Main Drainage Channels for Ngau
Tam Mei, Yuen Long and Kam Tin:
Environmental Schedule

23 May 1996

Response to Comments
Main Drainage Channels for Ngau Tam Mei, Yuen Long and Kam Tin, EIA Study - Draft Final Environmental Schedule

FIGURE 5.1j - PROPOSED WATER QUALITY MONITORING LOCATIONS FOR 22CD (PHASE 4) OF THE MDC

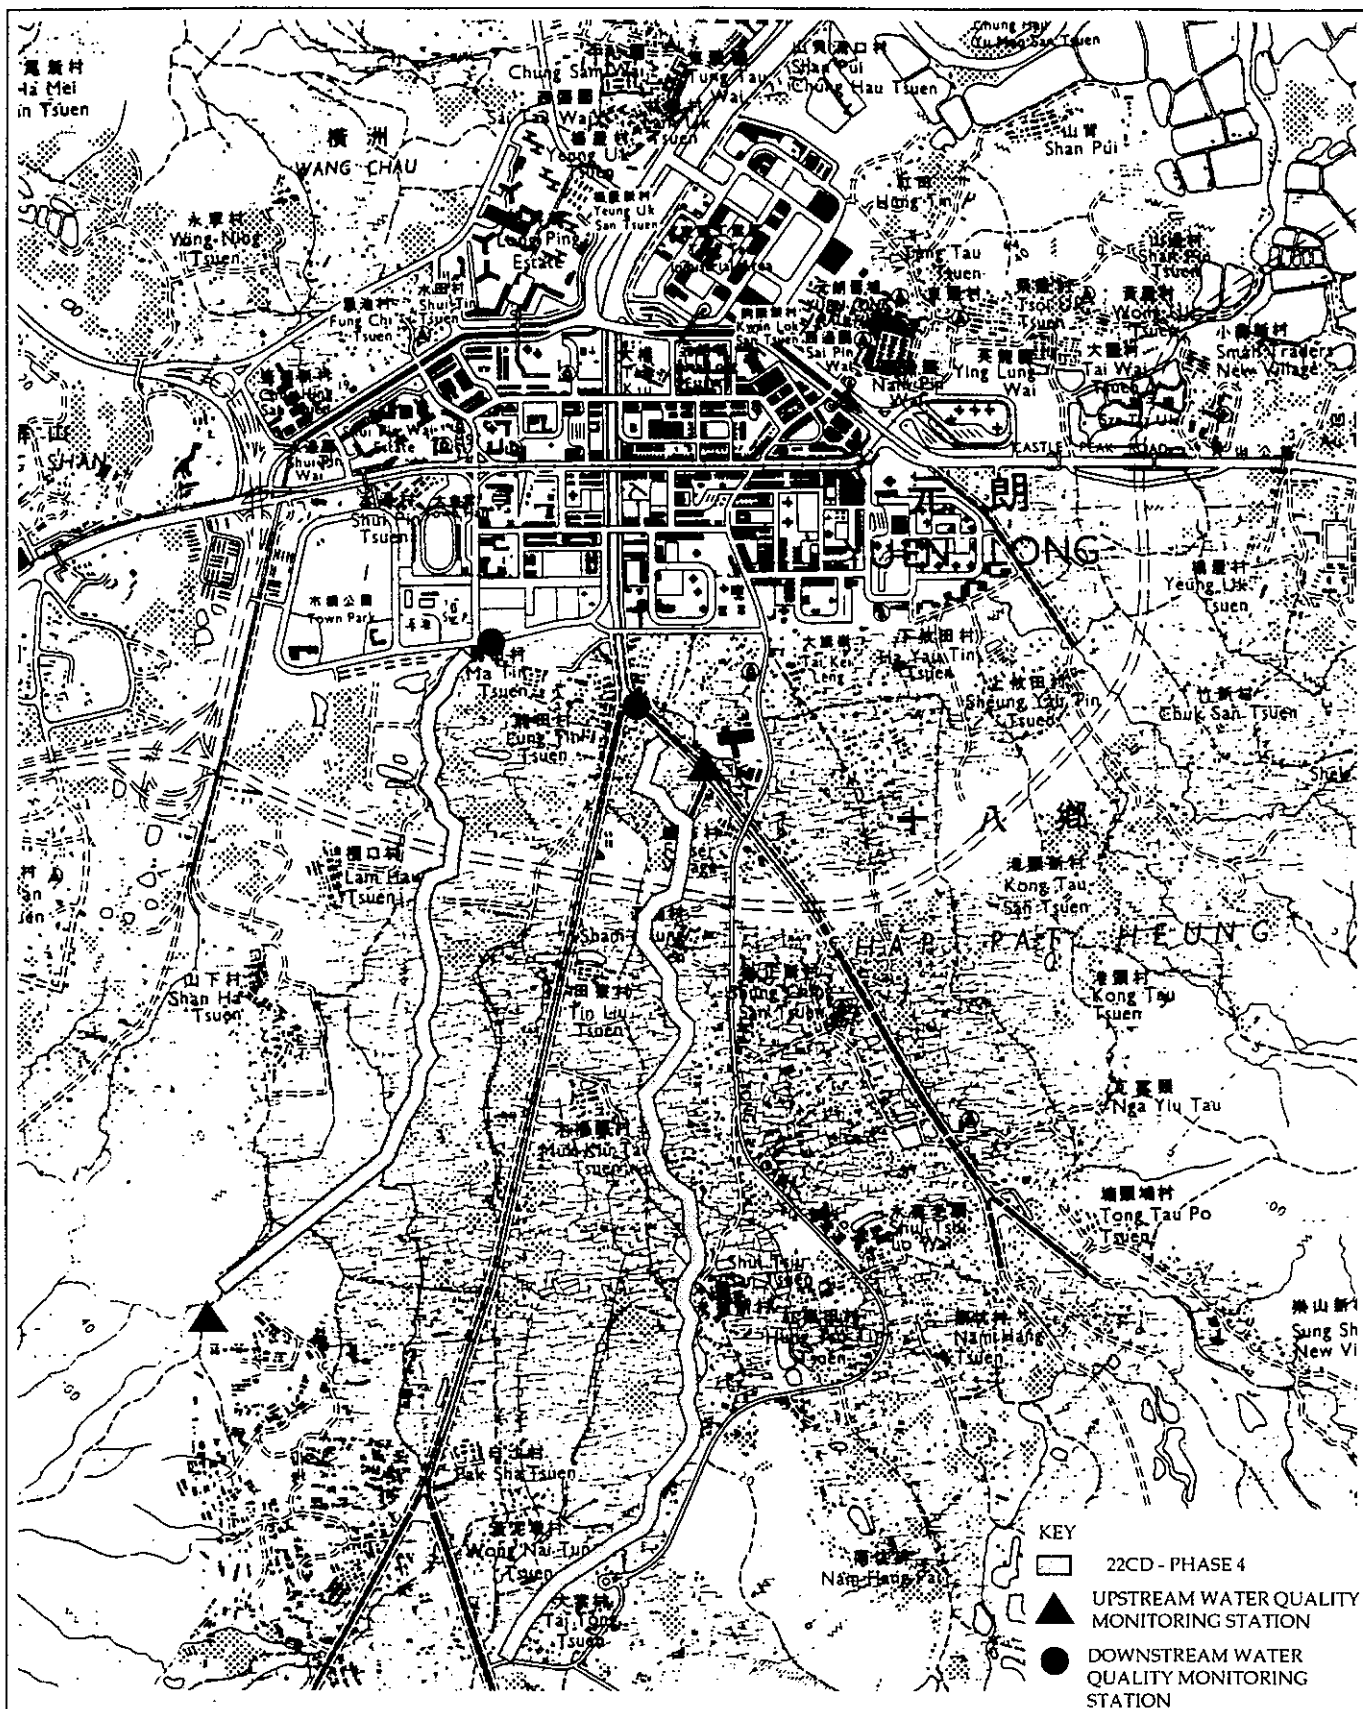
16.			ii) Figures 5.1a to 5.12k are not legible and should be further improved so that all the locations, grid co-ordination, existing rivers or streams and the construction areas can be well and clearly identified. Please make sure that all the monitoring and control stations are accessible and shown correctly in the drawings.	The clarify of all ES figures has been improved accordingly. See also response to comment 15 re: grid coordinates.
